31 August, 2012
Our File Ref: S12001AL101Rev0.docx
Contact: Michael Ward

**RE: BEGA VALLEY HEALTH REDEVELOPMENT HLS DESIGN
DOCUMENTATION REVIEW**

Following our original letter of advice dated 5 March 2012 (Ref: S12001AL001Rev1), as requested REHBEIN Airport Consulting has conducted a review of master plan concept designs provided by email on 12 July 2012 for the proposed new Bega Valley Hospital and HLS with regards to compliance with the relevant aviation guidelines and standards.

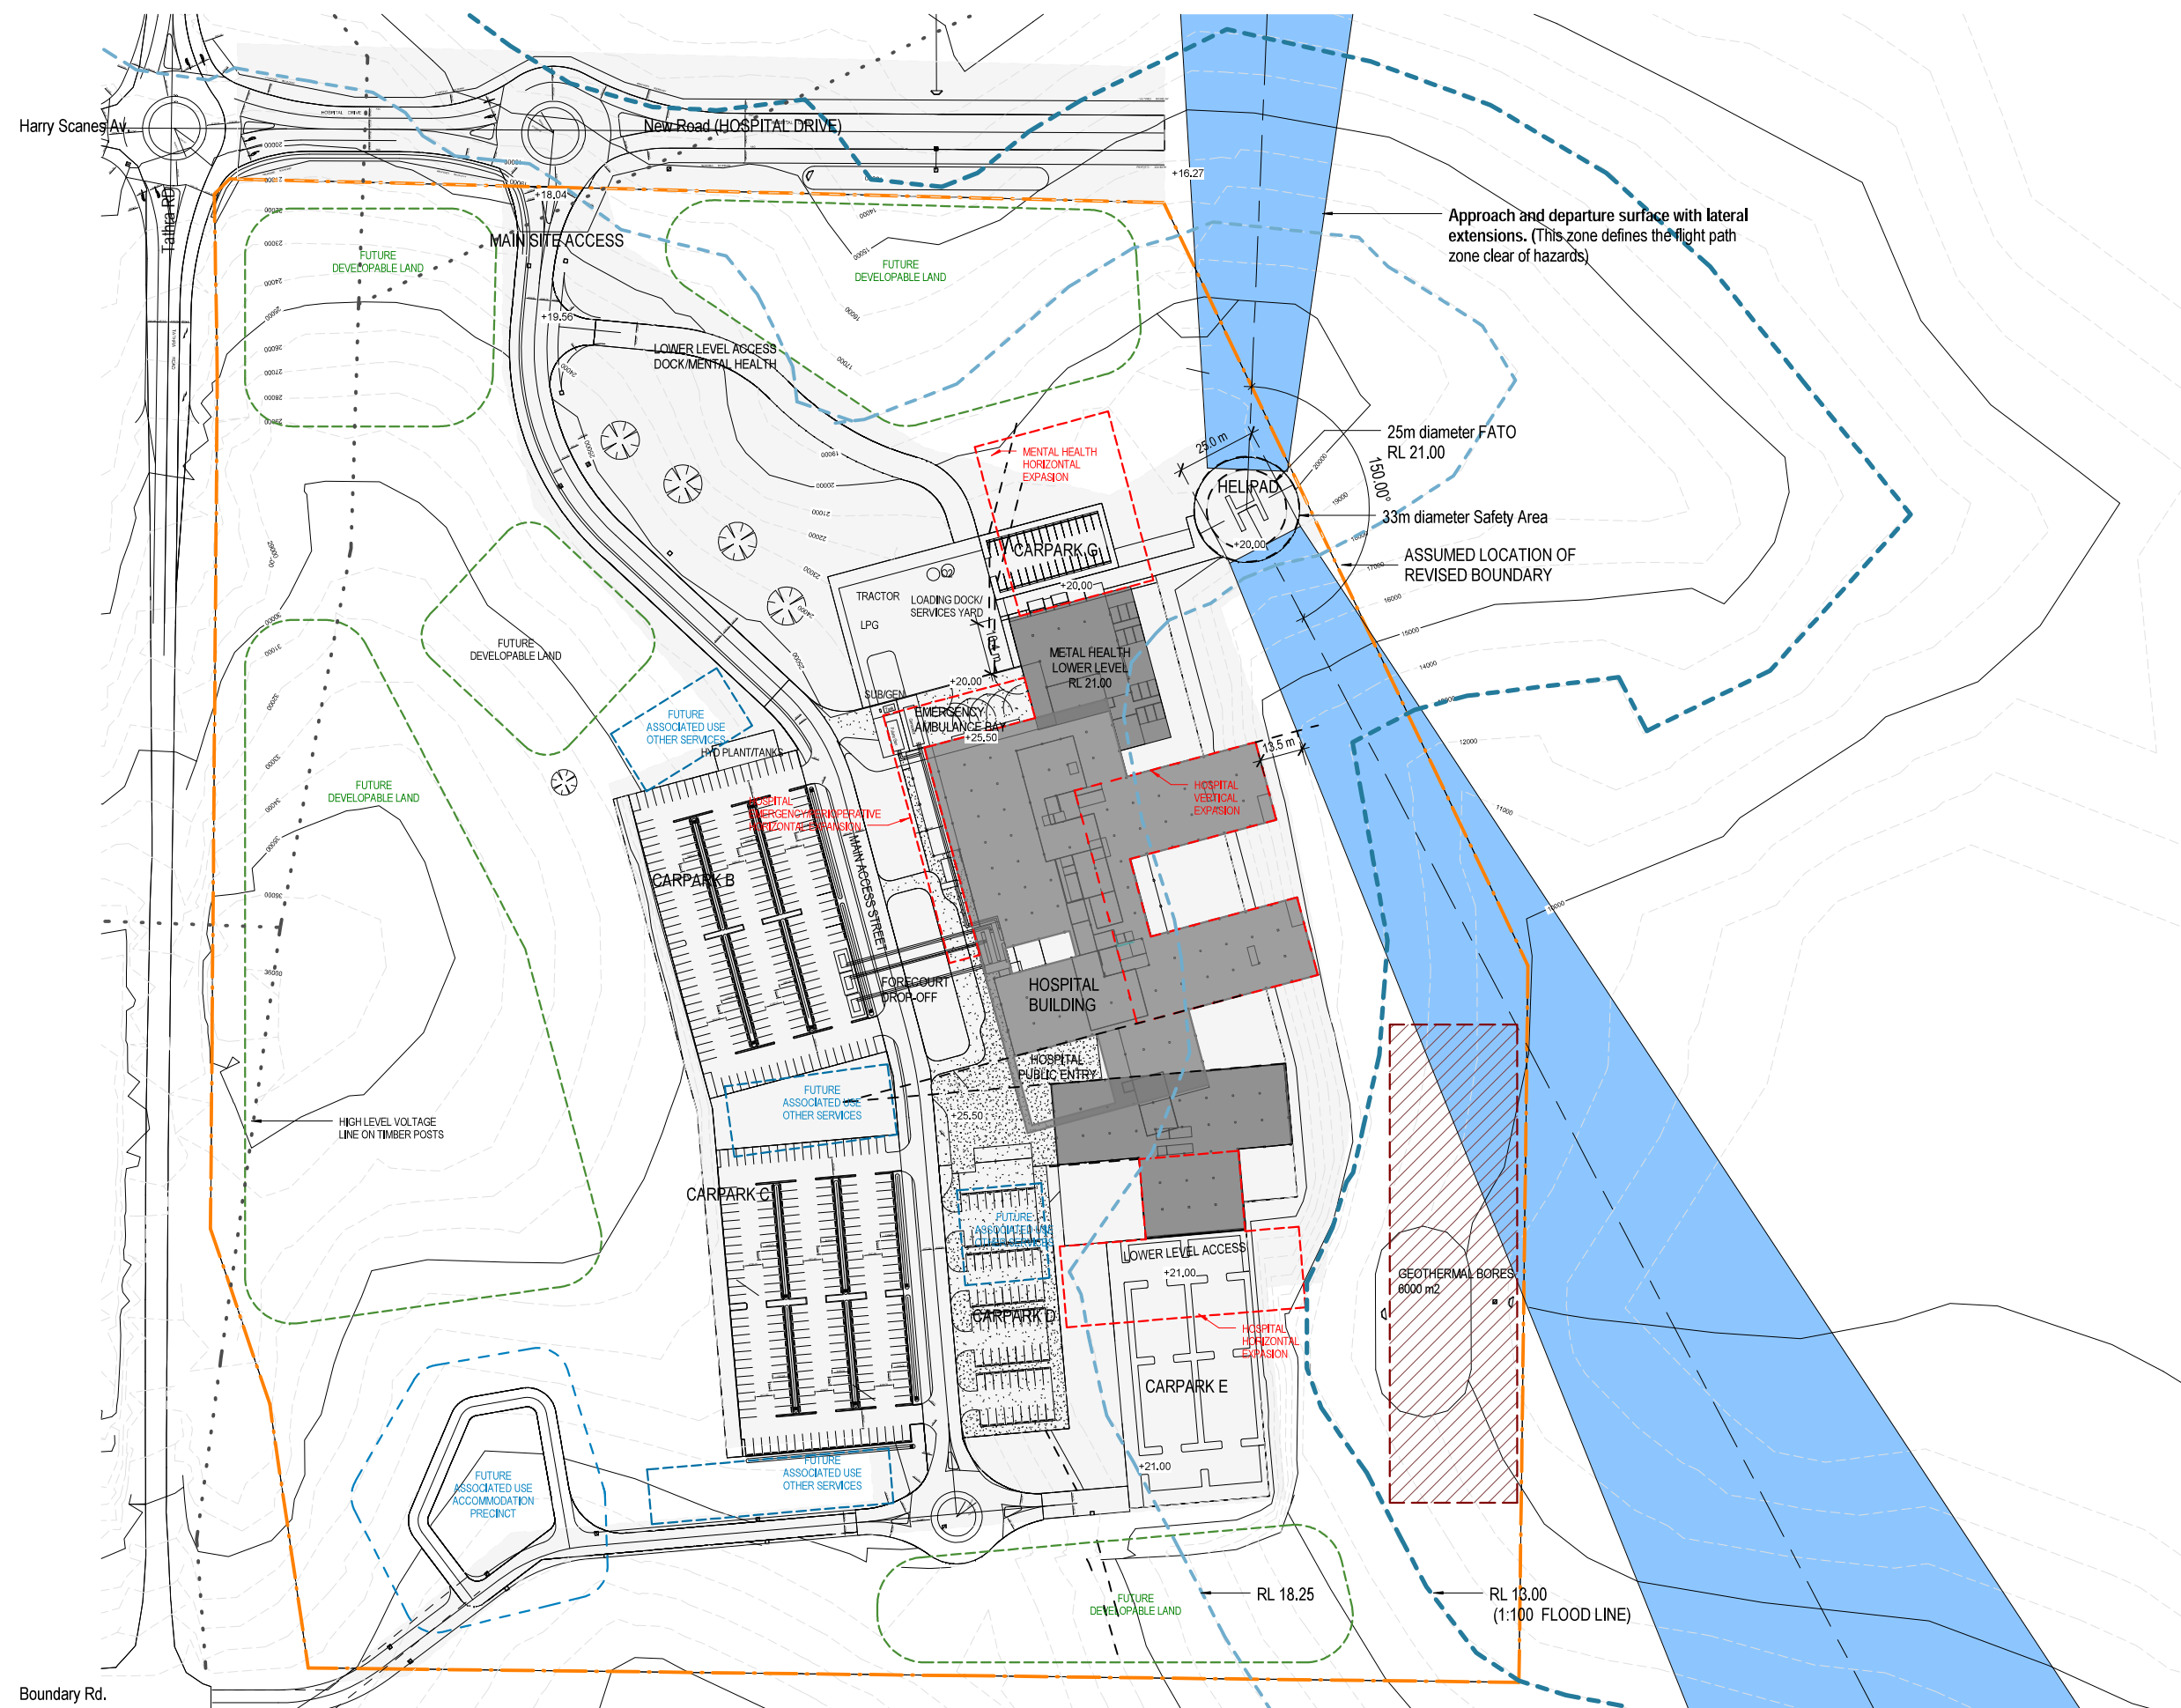
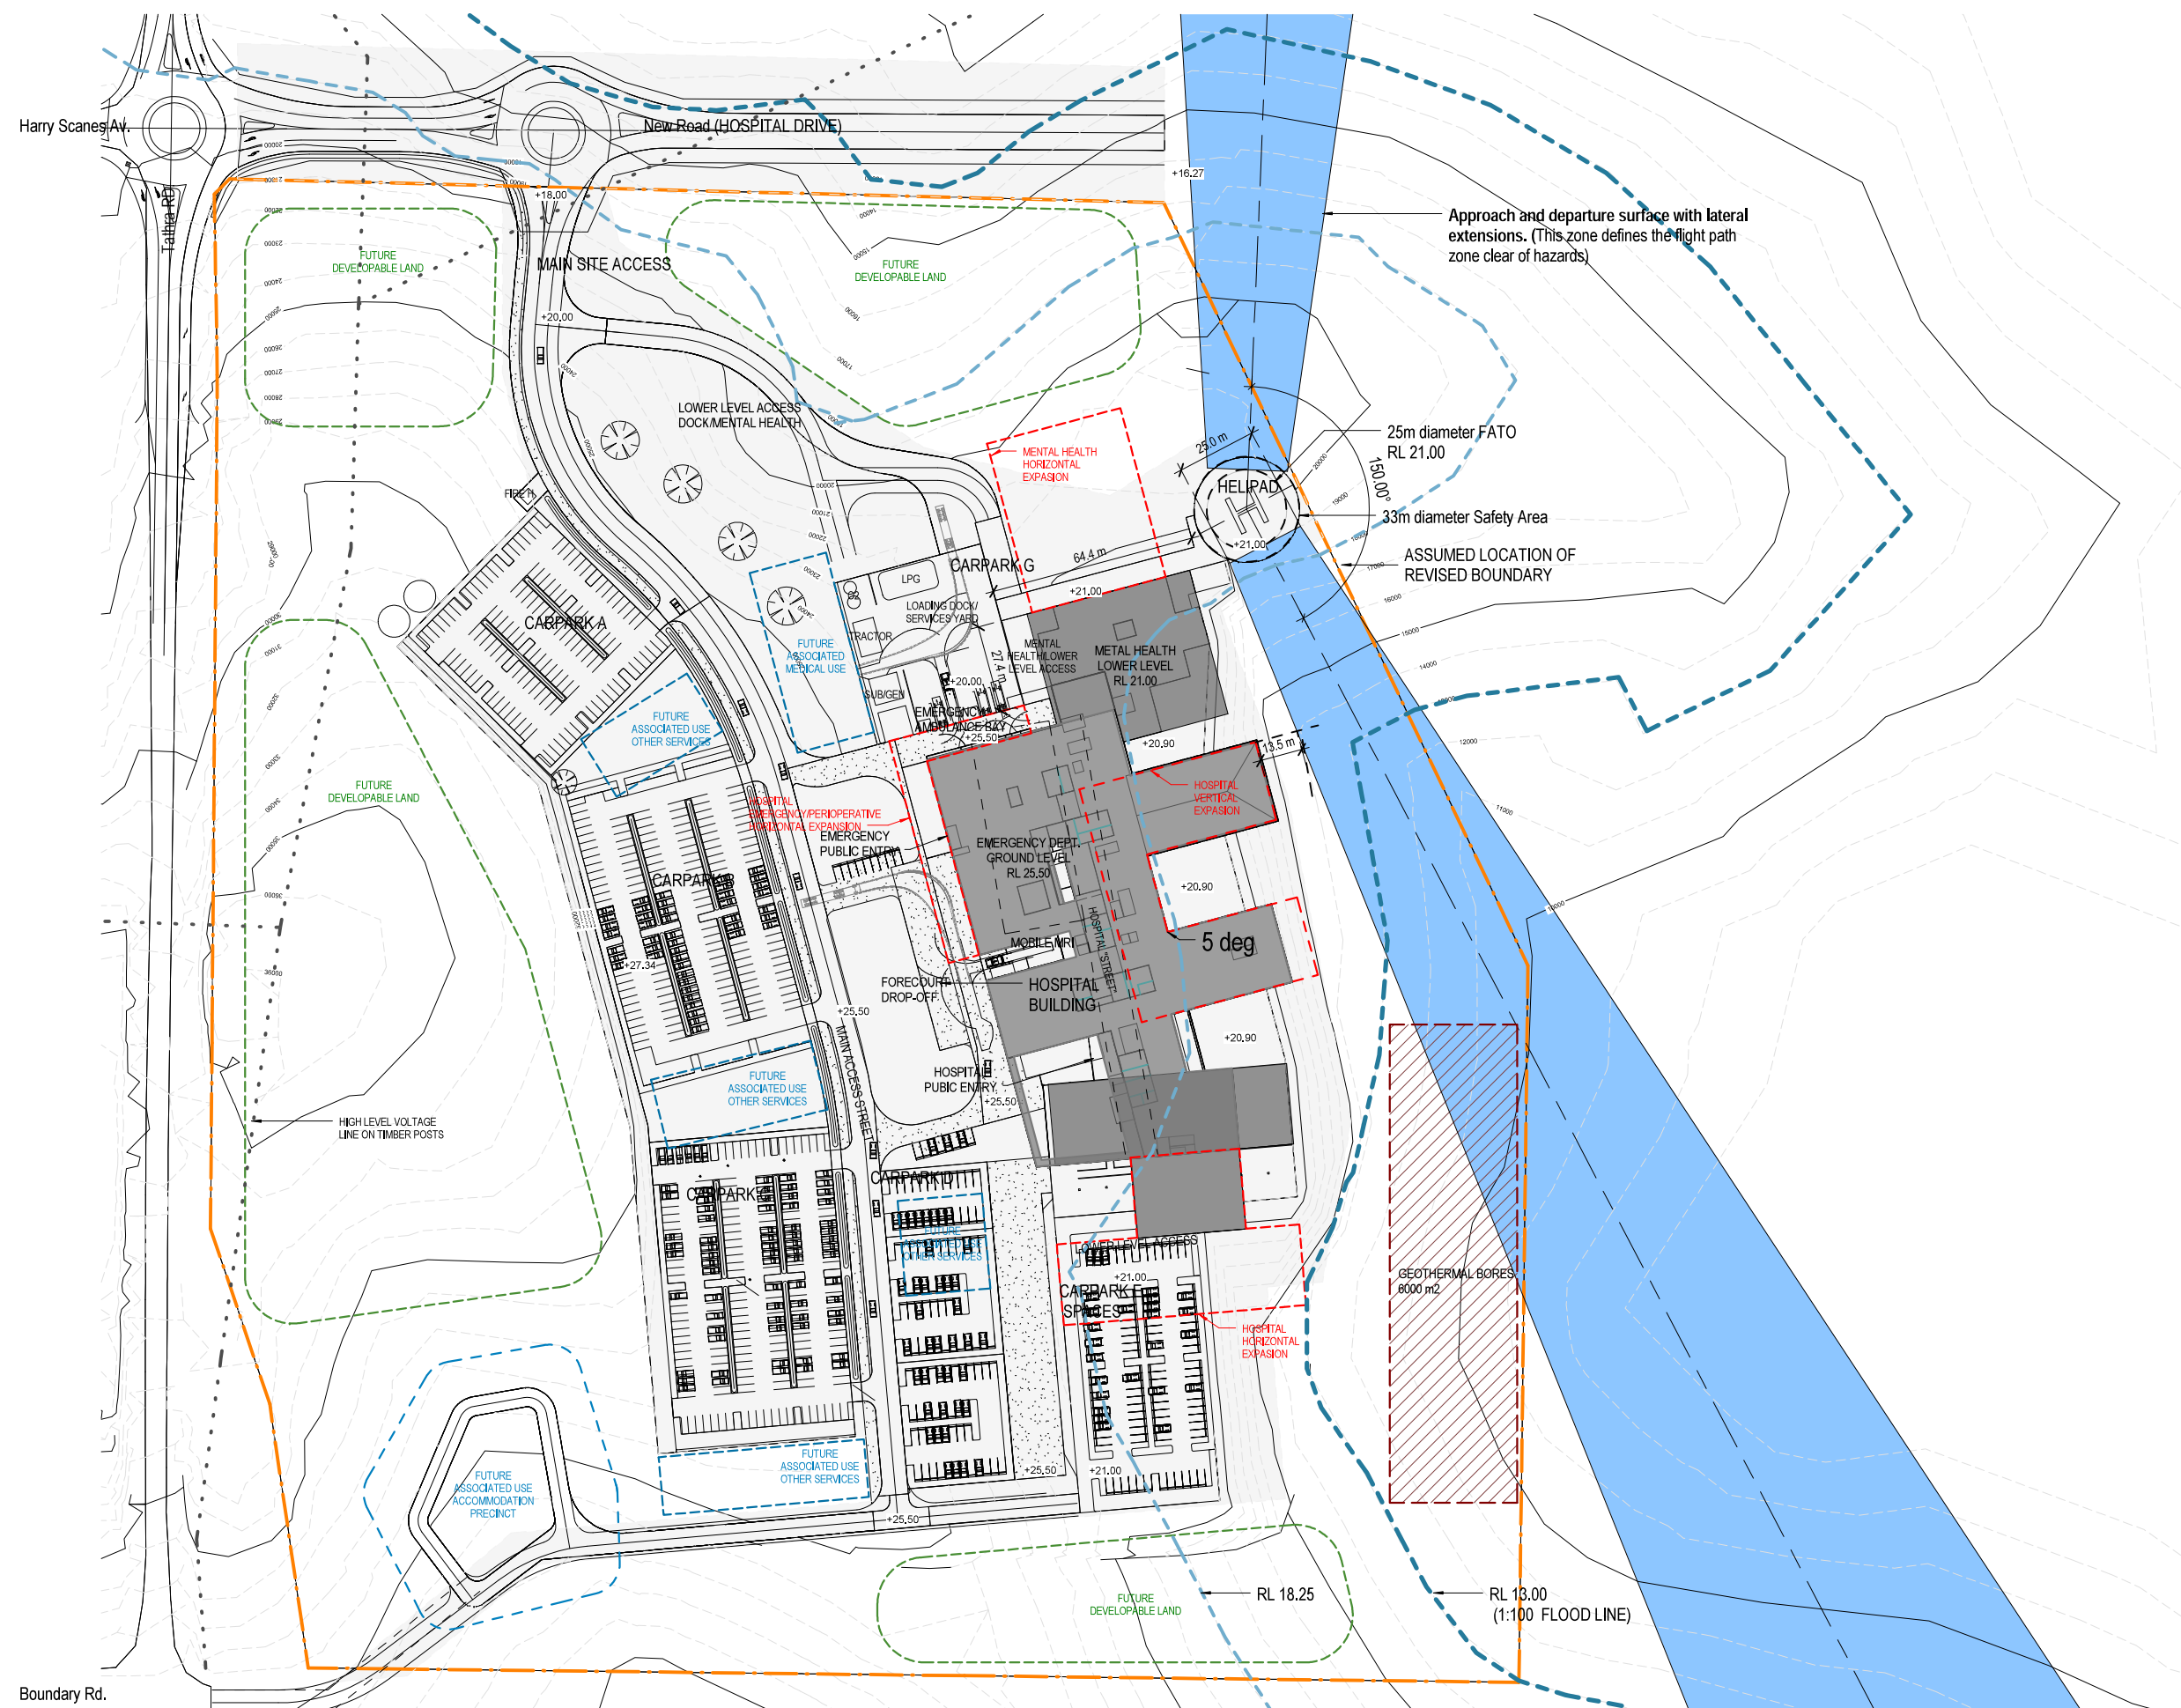
The diameter of the FATO proposed by BVN is 25m with a safety area of 4m around the FATO for a total diameter of 33m. These dimensions are in accordance with the draft NSW guidelines.

The proposed preferred flight paths are oriented 132° and 342° and are separated by a 150° obstacle free sector that can be used for arrivals and departures in high winds.

Wind analysis suggests that the preferred flight paths would provide approximately 75% usability and the entire 150° obstacle free sector should provide close to 100% usability.

The concept design documentation shows no potential obstacles under the preferred flight paths and associated Obstacle Limitation Surfaces (OLS) or within the 150° obstacle free sector.

The eastern wings of the proposed main hospital building are within the Obstacle Identification Surface (OIS) and may need to be lit for night helicopter operations. The requirements for obstacle lighting on the hospital building will need to be confirmed through consultation with the helicopter operators.

It should be noted that geothermal bores are indicated to the south east of the proposed HLS. Depending on their height above ground, objects in the area could potentially infringe the OLS. Proposals for this area should consider flight path protections requirements.
